## Answers to Comments by Mr. Staros on the Documents Presented by the Ukrainian Expert at the 4<sup>th</sup> Meeting of the Enquiry Commission

**Figure 1. Satellite Image Showing the Southern Section of the Chilia Delta**

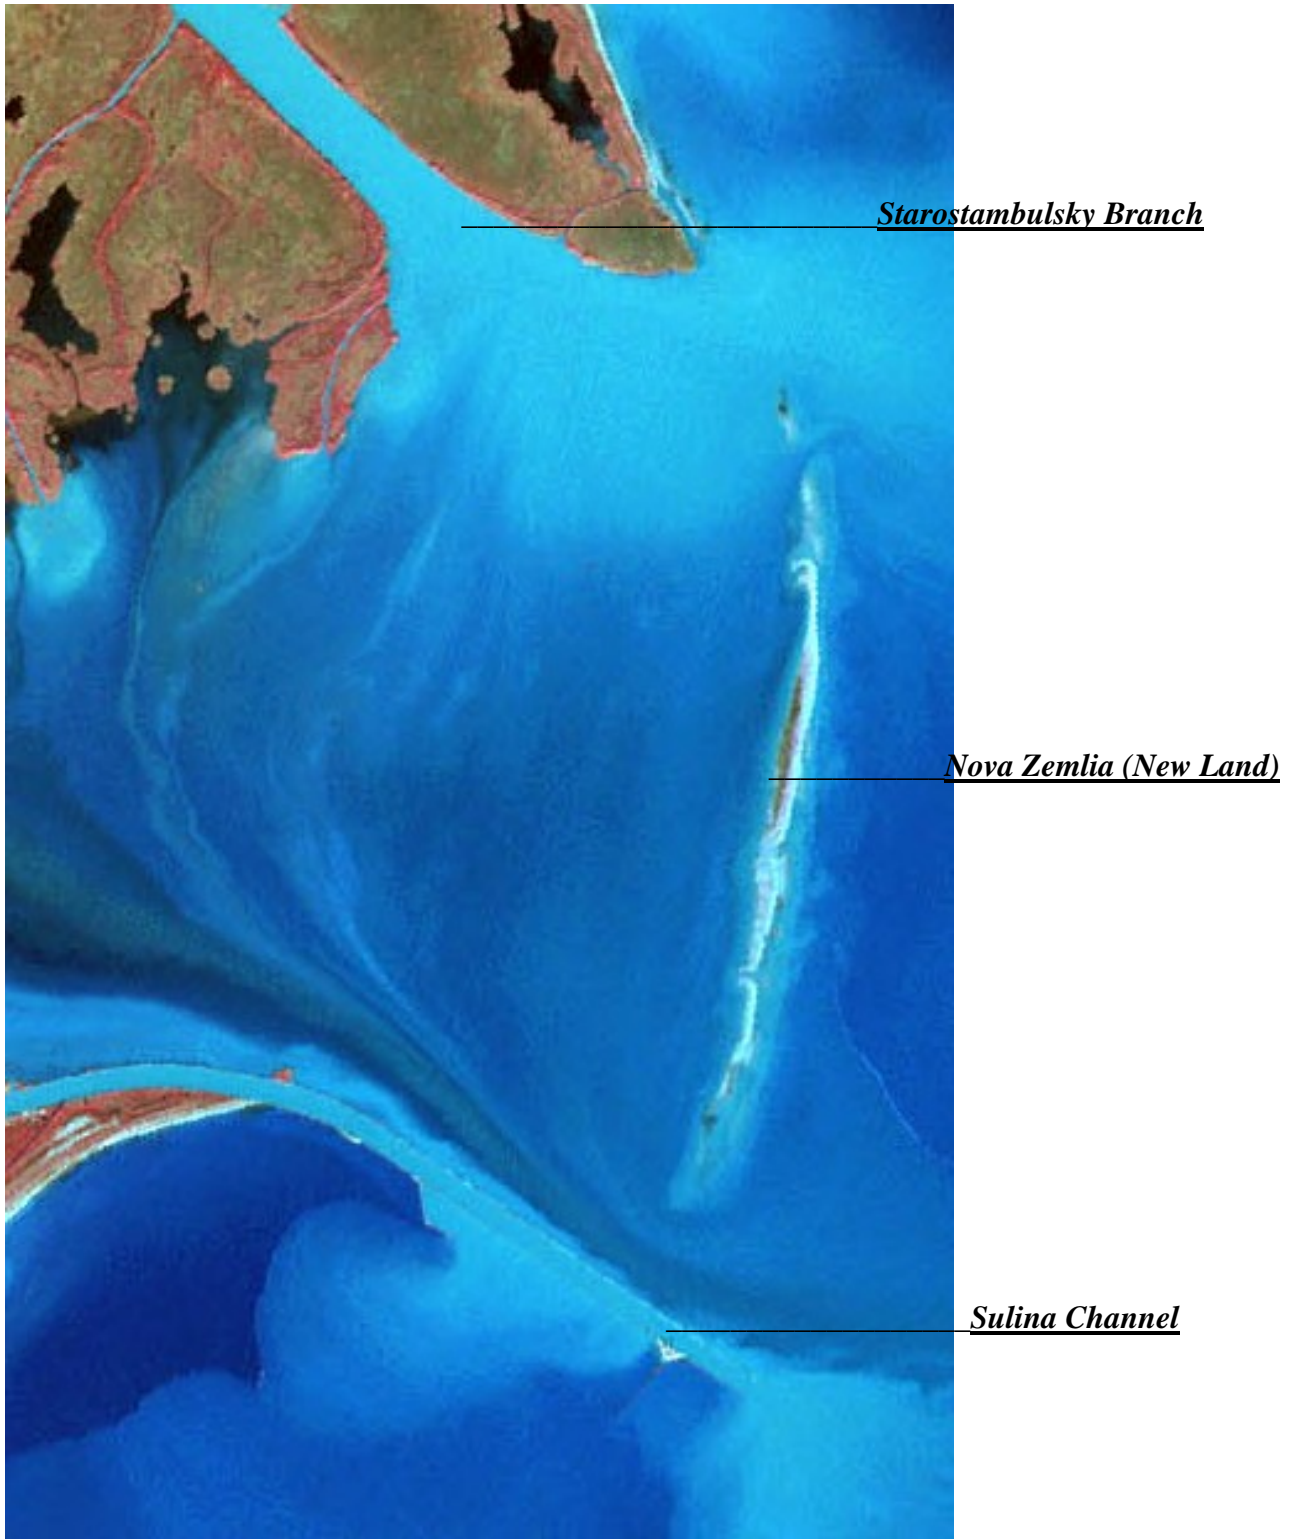
In any case, the evolving delta itself 'takes care' of continuing to function as a major habitat for birds through the formation of new spits. For example, it is expected that a new spit, named Nova Zemlia (New Land, see Figure 1 below), which has been formed at the Starostambulsky Branch mouth at 1 km distance from the coast, will have a longer lifecycle. This spit has already proved attractive for a multi-thousand colony of nesting birds. The available nesting capacity is more than sufficient to accommodate the loss of the Ptashyna Spit, while the nesting ultimate success and efficiency of nesting effort solely depends upon the Romanian party, because the strengthening of the Sulina Channel has the potential for adverse impact on the reproduction of birds in this area.
